## Dear teacher:

Thank you very much for your guidance and advice. We carefully read your suggestions, and revised the manuscript in accordance with your comments.

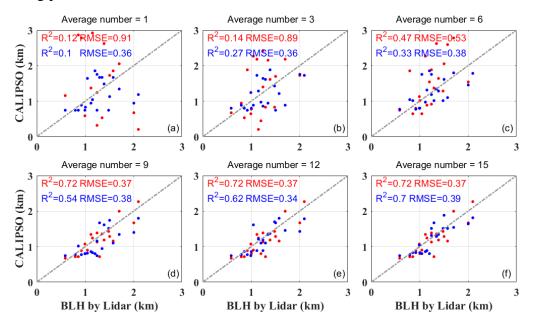
2. The reviewer's comment: Figure 9, this study shows the comparison between the BLHs from CALIPSO at 0210LT and RS at 2000LT. But the BLH has strong diurnal variances, this comparison is unreasonable. I suggest that the author change to RS data at night, or delete this comparison.

The authors' Answer: Thank you very much for your suggestion and guidance. As your said, due to the time mismatch, the comparison between the BLHs from CALIPSO at 0210LT and RS at 2000LT was unreasonable. So according to your suggestion, we delete the comparison between CALIPSO and RS. In addition, to make the results more robust, more CALIPSO profiles by different horizontal smoothing number was added

in Fig.9. The horizontal smoothing numbers of 1, 3, 6, 9, 12, and 15 (i.e., 1/3, 1, 2, 3, 4, and 5km in the along-track direction) are add to test the GDM algorithm, as the following picture shown.
